SUBJECT: ISSUANCE OF AMENDMENTS - JOSEPH M. FARLEY NUCLEAR PLANT,
 UNITS 1 AND 2 (TAC NOS. M99136 AND M99137)

The Nuclear Regulatory Commission has issued the enclosed Amendment No. 133 to Facility Operating License No. NPF-2 and Amendment No. 125 to Facility Operating License No. NPF-8 for the Joseph M. Farley Nuclear Plant, Units 1 and 2. The amendments change the Technical Specifications (TS) in response to your submittal dated June 30, 1997, as supplemented September 25, 1997. The revision supplemented the TS Bases to discuss credit for boraflex panels in the revised criticality analysis. The staff found that the supplement did not change the conclusions of the proposed no significant hazards consideration; therefore, renotification of the Commission's proposed determination of no significant hazards consideration was not necessary.

The amendments change the Farley TS to incorporate requirements necessary to change the basis for prevention of criticality in the fuel storage pool. The change eliminates the credit for Boraflex as a neutron absorbing material in the fuel storage pool criticality analysis. The change also establishes an alternate method for maintaining the recomm

Figure 5.6-2 Spent Fuel Storage Configurations

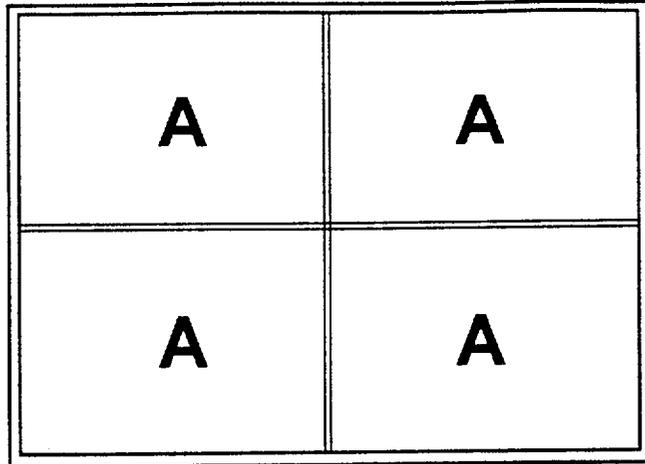
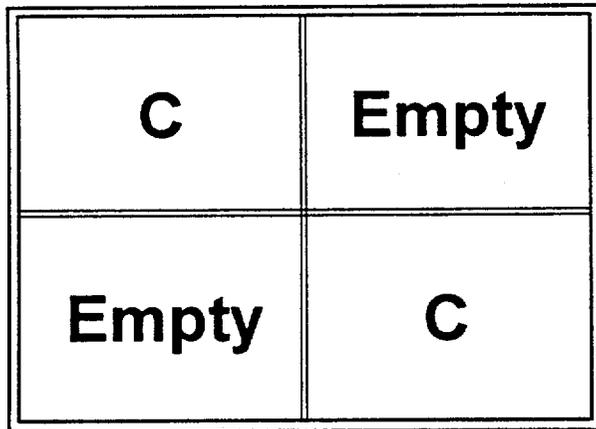
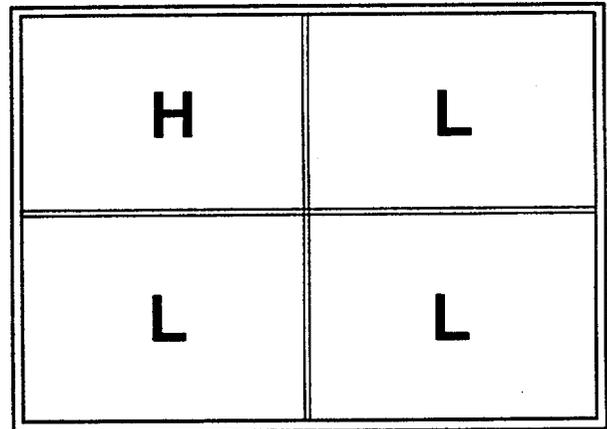
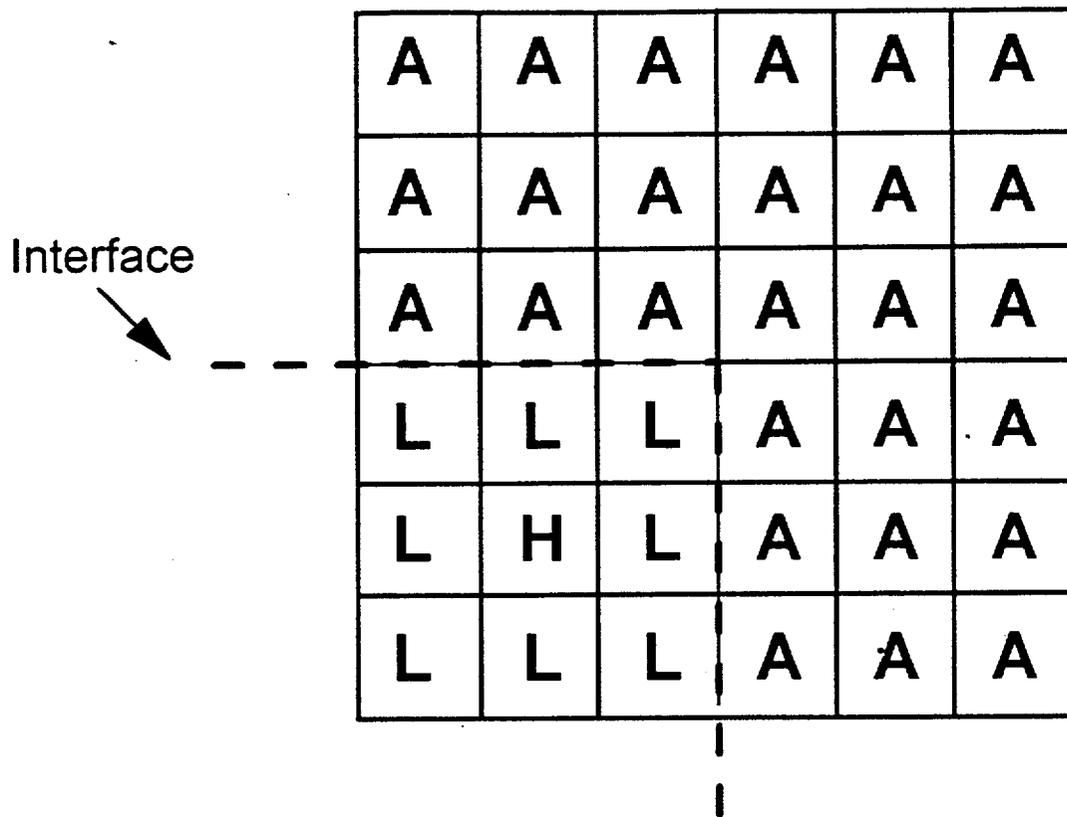
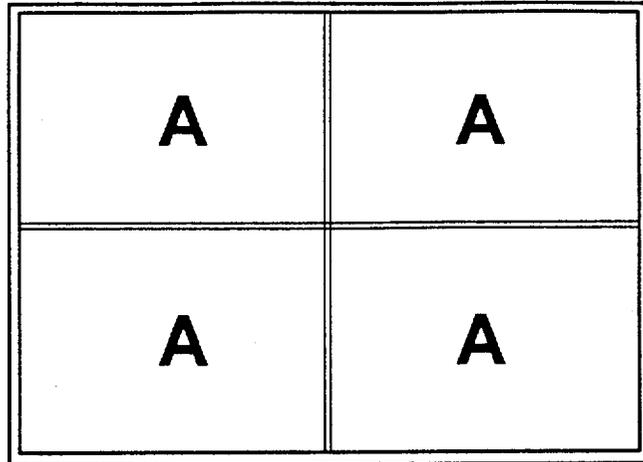
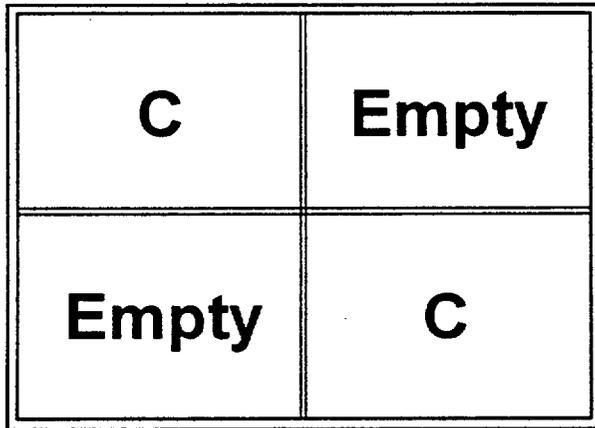
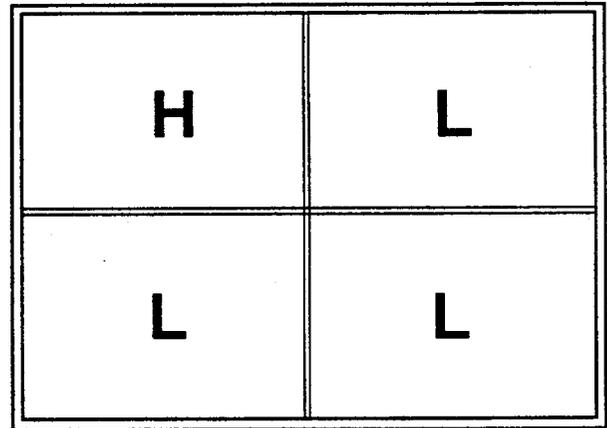
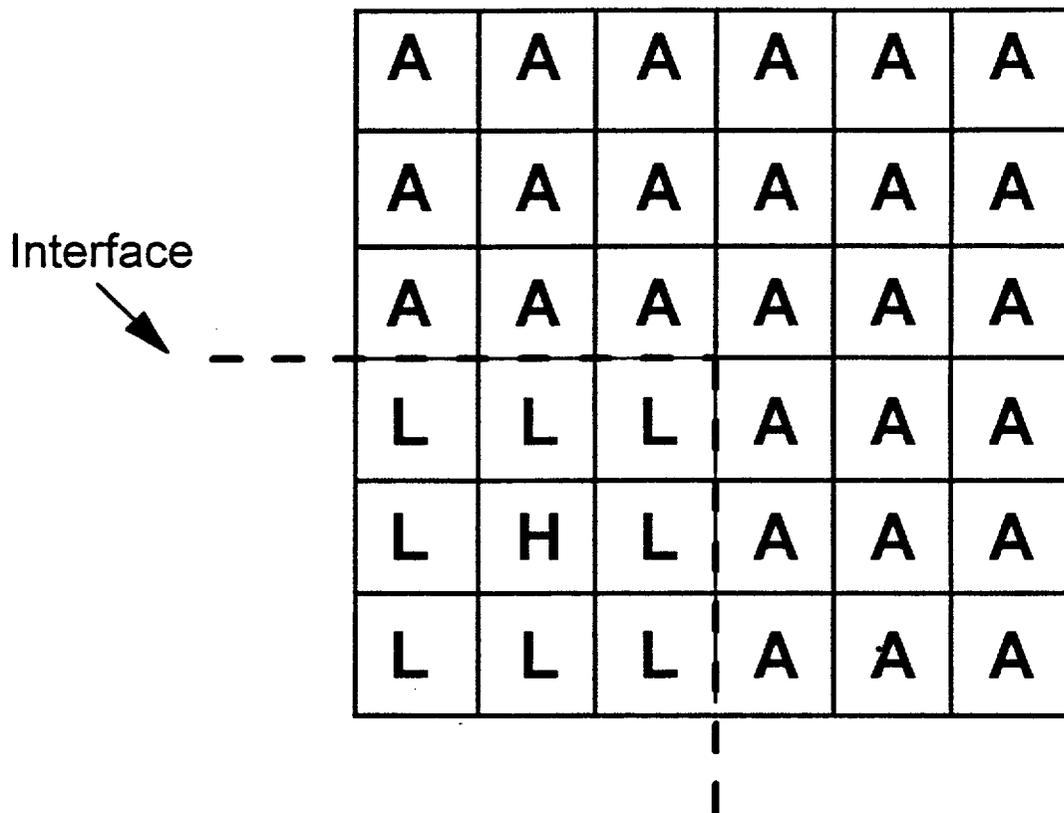
- e. New or partially spent fuel assemblies with a combination of discharge burnup and initial enrichment in the "acceptable range" of Figure 3.7-1 may be allowed unrestricted storage in the spent fuel racks (also shown as the All Cell Storage configuration in Figure 5.6-2).

Westinghouse 17X17 fuel assemblies with nominal enrichments less than or equal to 5.0 w/o U-235 can be stored in a 2 out of 4 checkerboard arrangement as shown in Figure 5.6-2. In the 2 out of 4 checkerboard storage arrangement, 2 fuel assemblies can be stored corner adjacent with 2 empty storage cells.

Westinghouse 17X17 fuel assemblies can be stored in a burned/fresh checkerboard arrangement of a 2X2 matrix of storage cells as shown in Figure 5.6-2. In the burned/fresh 2X2 checkerboard arrangement, three of the fuel assemblies must have an initial nominal enrichment less than or equal to 1.6 w/o U-235, or satisfy a minimum burnup requirement for higher initial enrichments as shown in Figure 5.6-1. The fourth fuel assembly must have an initial nominal enrichment less than or equal to 3.9 w/o U-235, or satisfy a minimum Integral Fuel Burnable Absorber requirement for higher initial enrichments to maintain the reference fuel assembly k_{eff} less than or equal to 1.455 at 68° F.

Figure 5.6-3 Interface Requirements

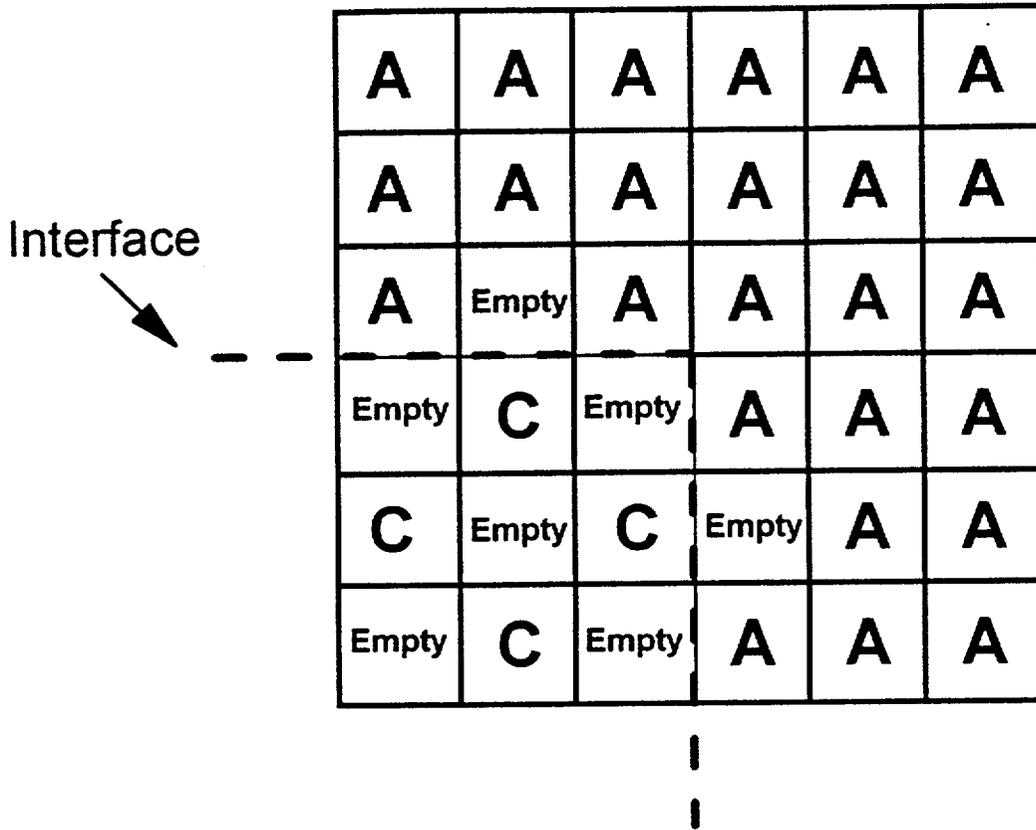
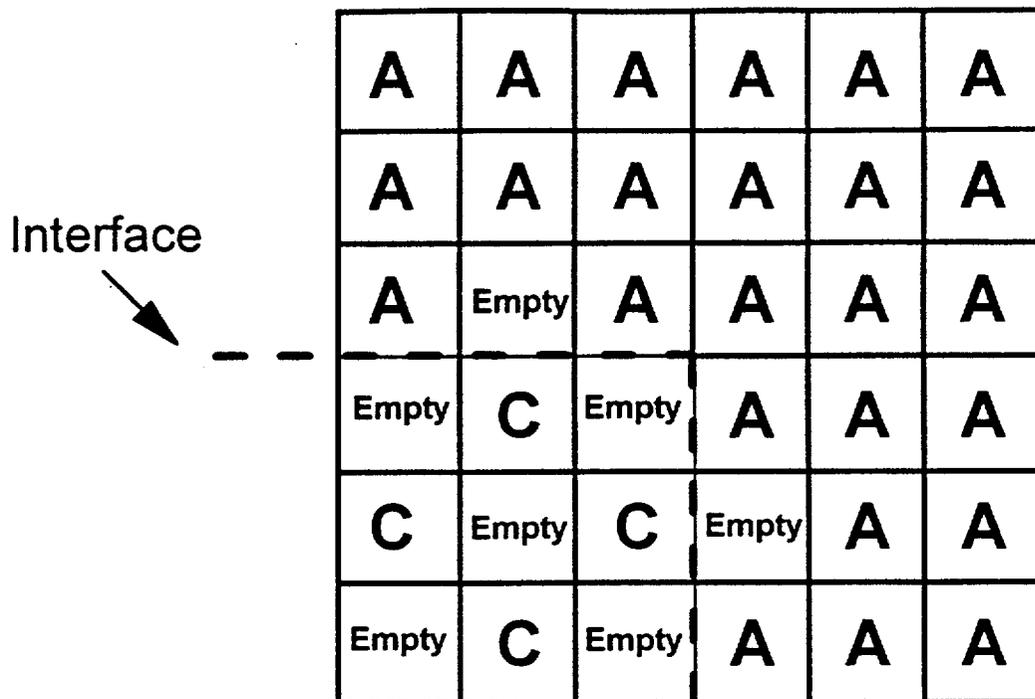
In order to prevent an undesirable increase in reactivity, the boundaries between the different storage configurations were analyzed. The interface requirements are shown in TS Figures 5.6-3 through 5.6-6. The TS changes proposed as a result of the revised criticality analysis are consistent with the changes stated in the NRC Safety Evaluation (SE) for WCAP-14416-P. Westinghouse submitted a revised Topical Report, WCAP-14416-NP-A, Rev. 1, which incorporated the changes stated in the NRC SE. Also, since the staff disagreed with the proprietary finding of the original WCAP-14416-P, Westinghouse's revised topical report was submitted as a nonproprietary version. Based on this consistency with the approved methodology and on the above evaluation, the staff finds these TS changes acceptable. The proposed associated Bases changes adequately describe these TS changes and are also acceptable.
